SOUTH DAKOTA PUBLIC UTILITIES COMMISSION

CASE NO. EL05-022

CONSTRUCTION OF THE BIG STONE II PROJECT

PREFILED REBUTTAL TESTIMONY

EXHIBIT
Applicants'
EXHIBIT 33-A

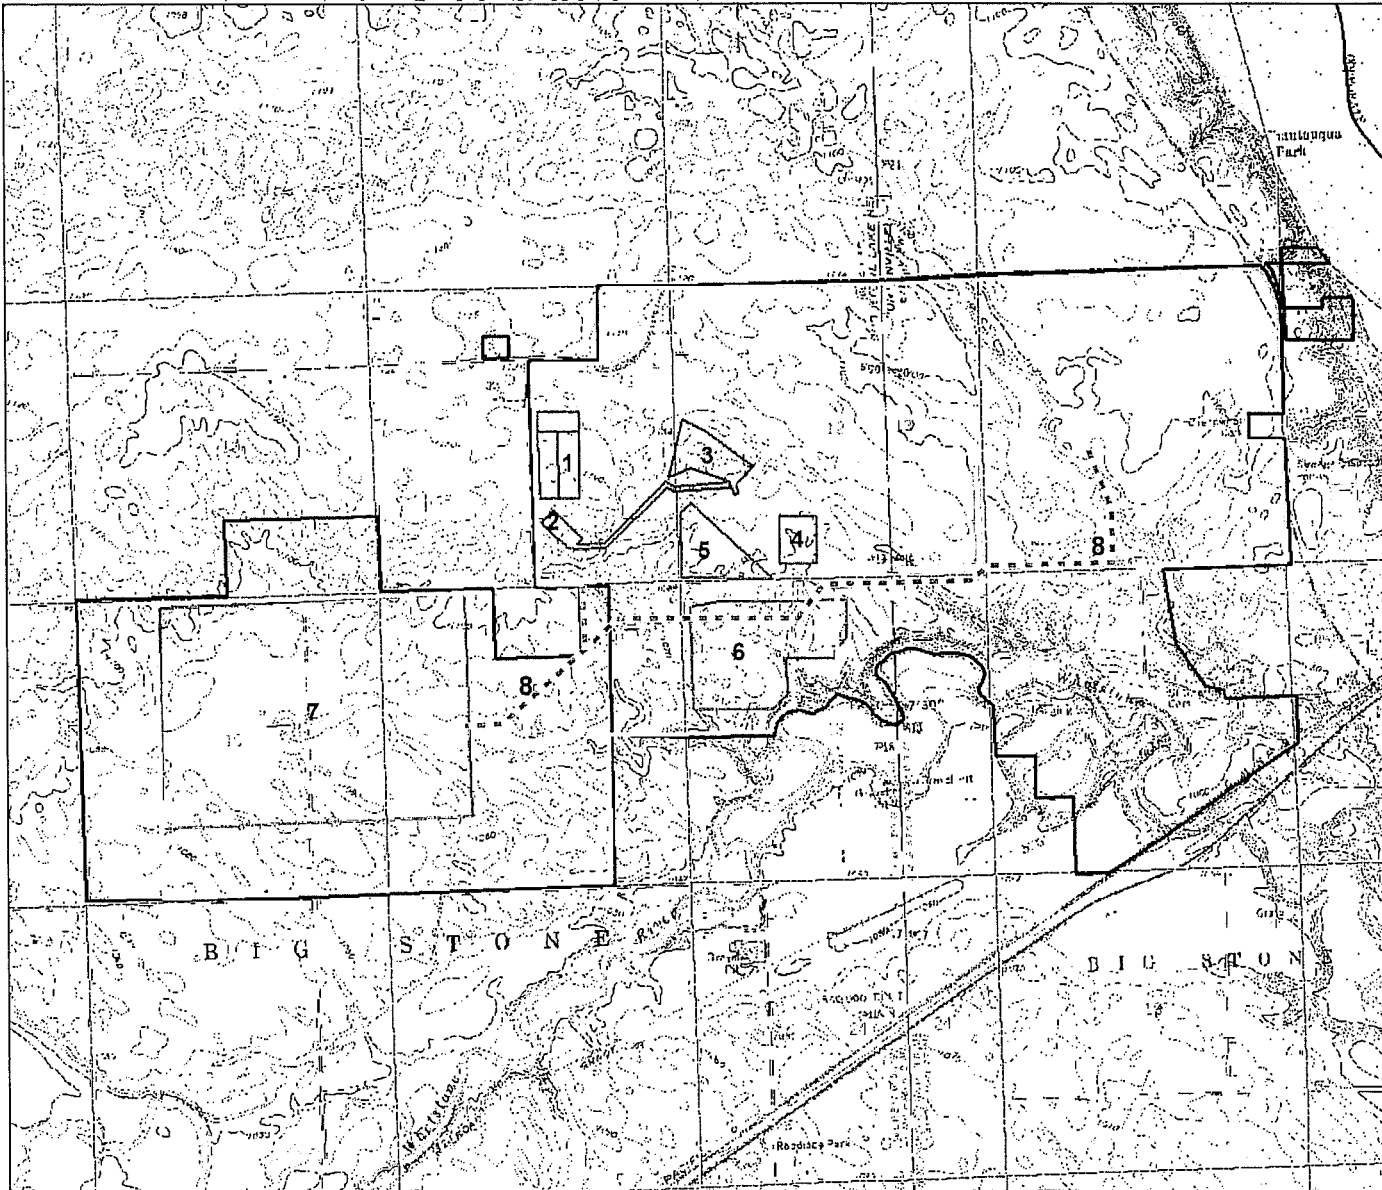
12 The Applicants have taken options on or purchased five additional pieces of property that
 13 will increase the plant site buffer area. The residence closest to the plant site, which is north and
 14 west of the plant, has been purchased. The Applicants also have purchased or taken options on
 15 additional properties to the north and west of the proposed water storage ponds, and taken an
 16 option on one of the residents to the south of the water storage ponds. The Project site, including
 17 these additional properties, is shown on Applicants' Exhibit 33-A.

19 The Applicants plan to have an enlarged construction lay down area with a railspur
 20 leading from the plant's main railspur into the lay down area to facilitate delivery of material by
 21 rail. The expansion of the lay down area would occur on additional property to the east. All of

1 the lay down area would be returned to its original state following construction. The lay down
 2 area is shown on Applicants' Exhibit 33-A.

EXHIBIT
 Applicants
 Exhibit 33-B

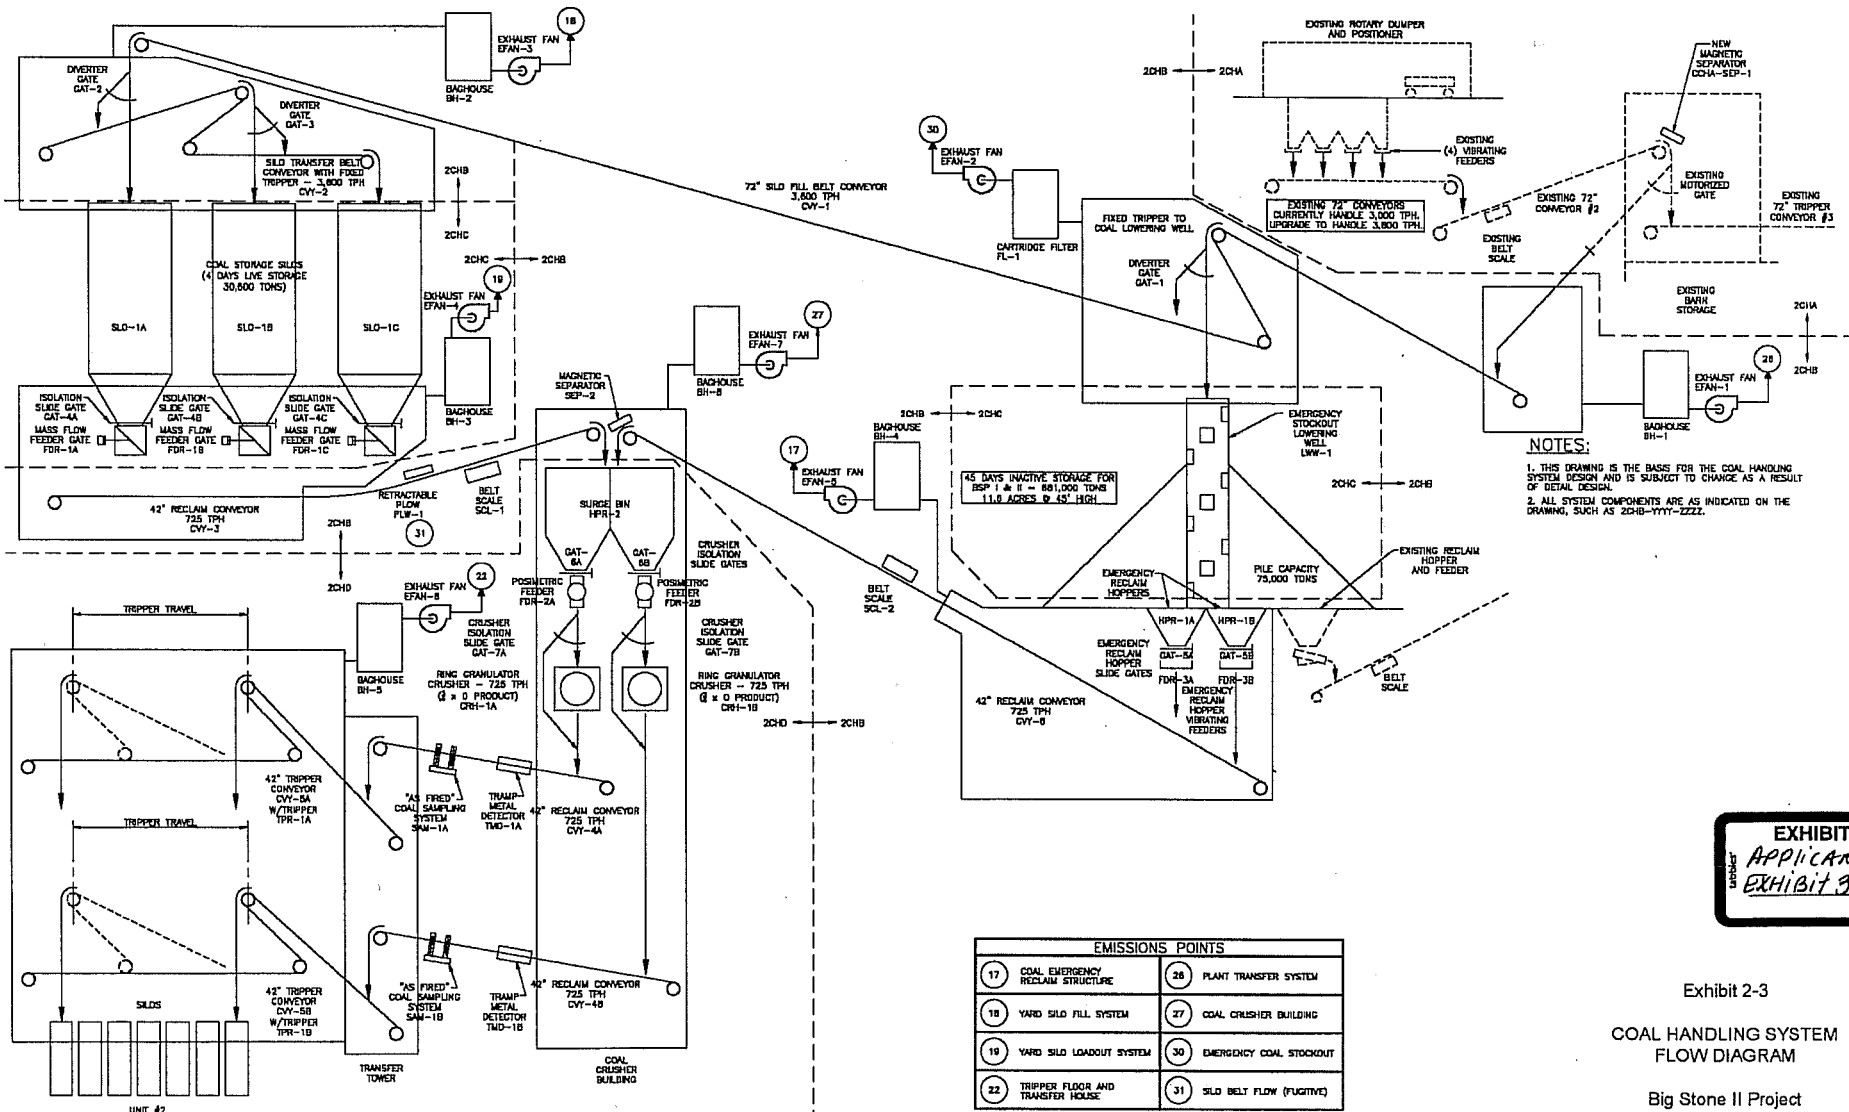
4 A revised site layout for the plant is attached as Applicants' Exhibit 33-B, and shows the
 5 exact size and location of the plant structures. The changes are minor and are confined to the
 6 areas adjacent to the existing plant structures.

8 Because of revisions to the higher National Fire Protection Code, we are evaluating
 9 whether or not two additional diesel powered booster fire pumps will need to be added. One is
 10 for the main boiler building and the second is for the coal silos to provide enhanced water
 11 pressure at the elevated locations. The proposed locations of the fire pumps are shown on
 12 Applicants' Exhibit 33-B.

14 Because of the current water balance it may prove to be more practical to add two brine
 15 concentrators, rather than one. The final decision on the number of brine concentrators has yet to
 16 be made. If two concentrators are used, they will be located adjacent to the existing brine
 17 concentrator that is shown on Applicants' Exhibit 33-B.

EXHIBIT
 APPLICANTS'
 EXHIBIT 33-C

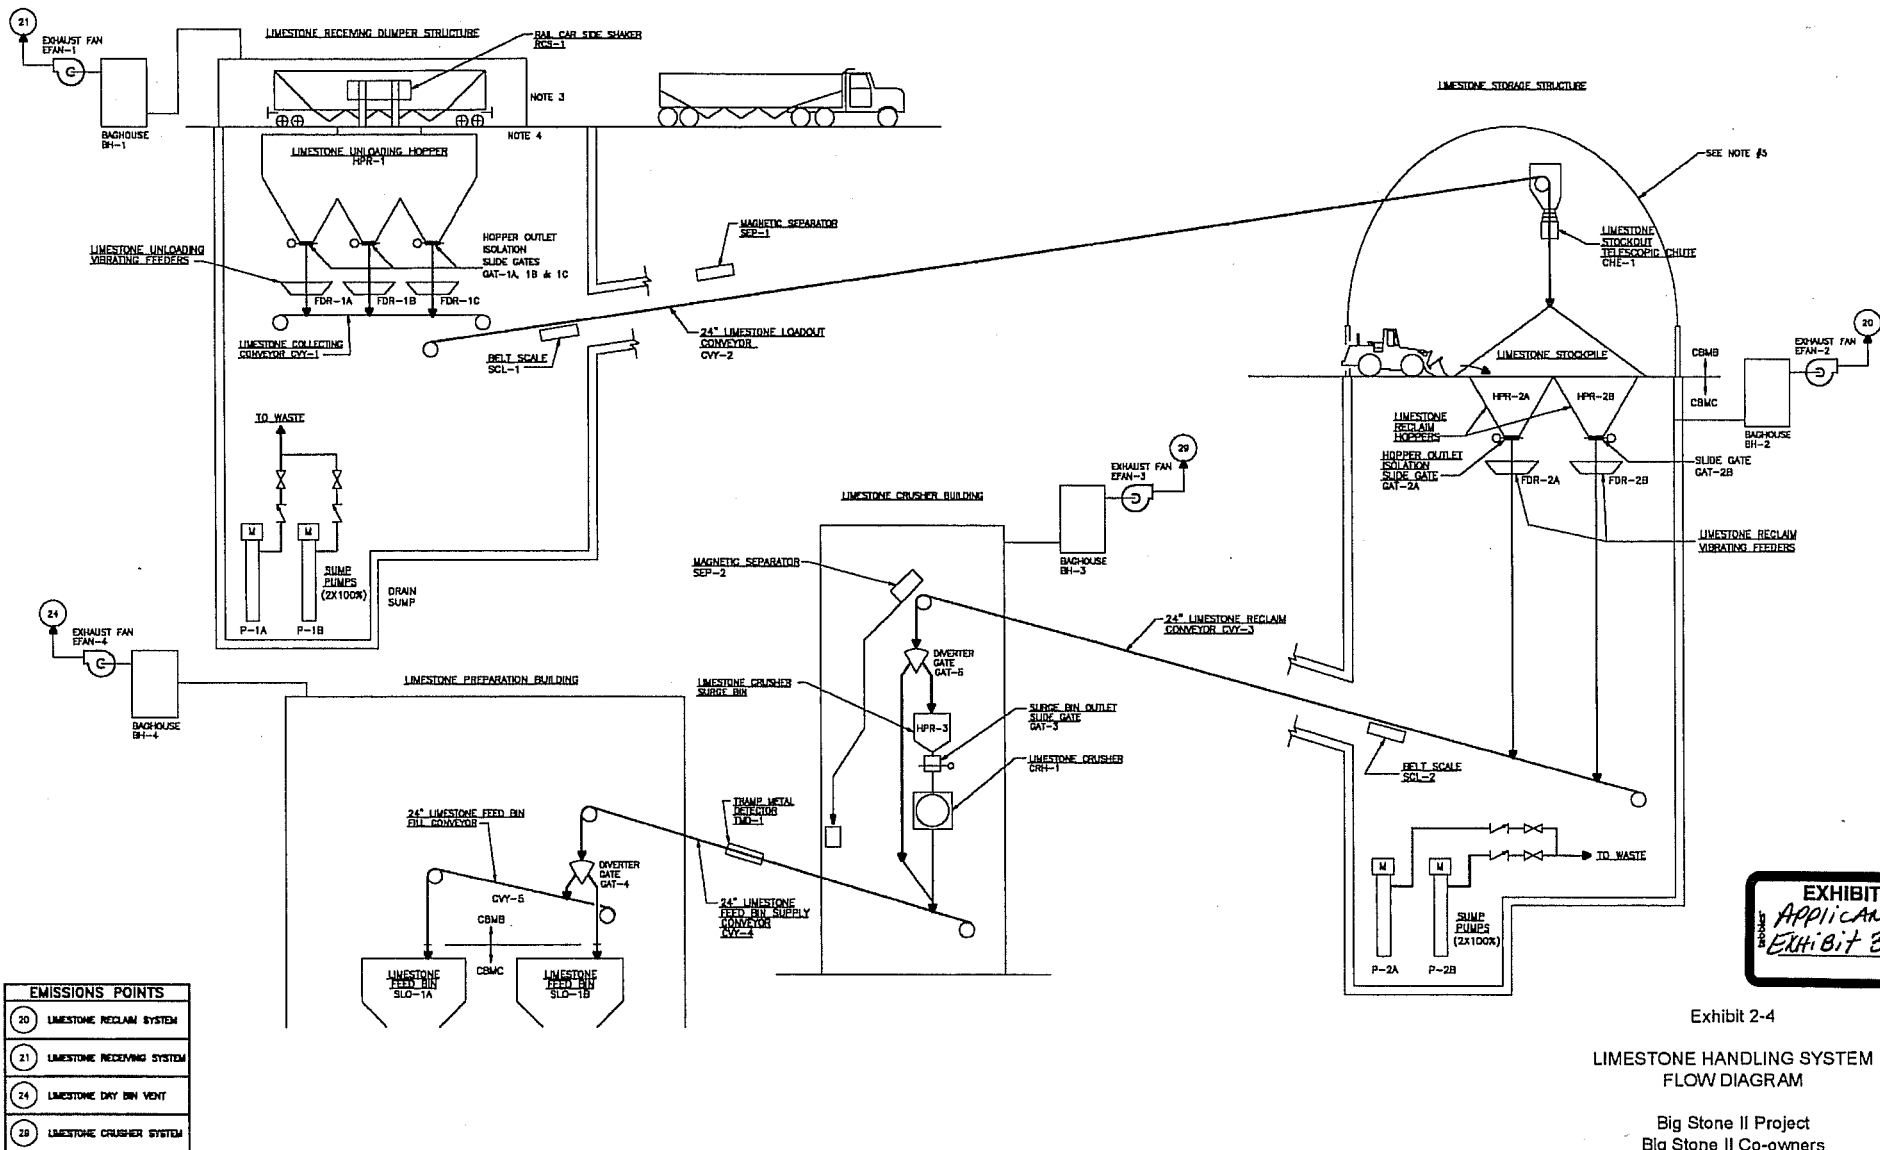
19 The original design for the coal stock out was a retractable plow and telescopic chute.
 20 We are evaluating whether to replace this with a fixed tripper and fabric filter dust collector and
 21 lowering well, as this arrangement is anticipated to provide better dust control and serviceability

1 of the coal stock out operation. These proposed facilities are also shown on Applicants' Exhibit
 2 33-C.

4 With the previous mentioned proposed change of the telescopic chute to a lowering well,
 5 the active coal stockpile capacity would change from 28,000 tons to an estimated 75,000 tons.

6 See Applicants' Exhibit 33-C.

8 A proposed retractable plow would be added to the conveyor from the storage silos to
 9 provide for emergency emptying of the silos. The location of the plow is shown on Applicants'
 10 Exhibit 33-C.

Exhibit 2-5

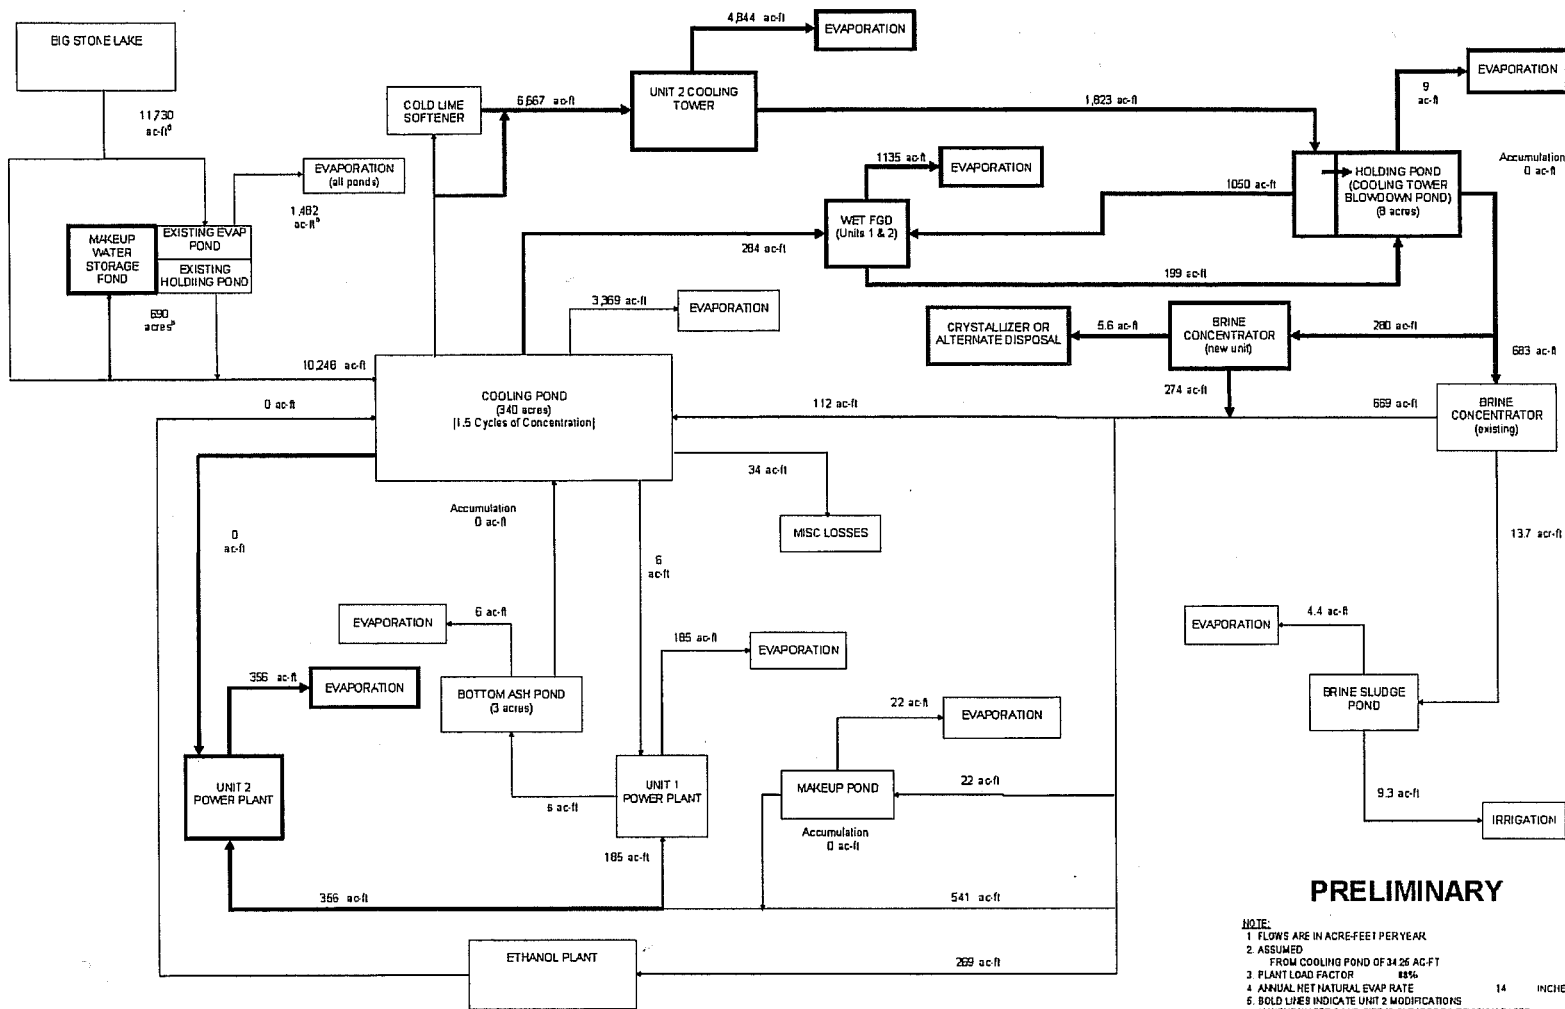
1 The water balance has been revised to include an annual average total fresh water make
2 up of approximately 11,700 acre-feet per year for both units. This is due to better design
3 knowledge and assumptions for the water balance and water consumption. The water supply
4 system and its typical evaporation are shown on Applicants' Exhibit 33-E.
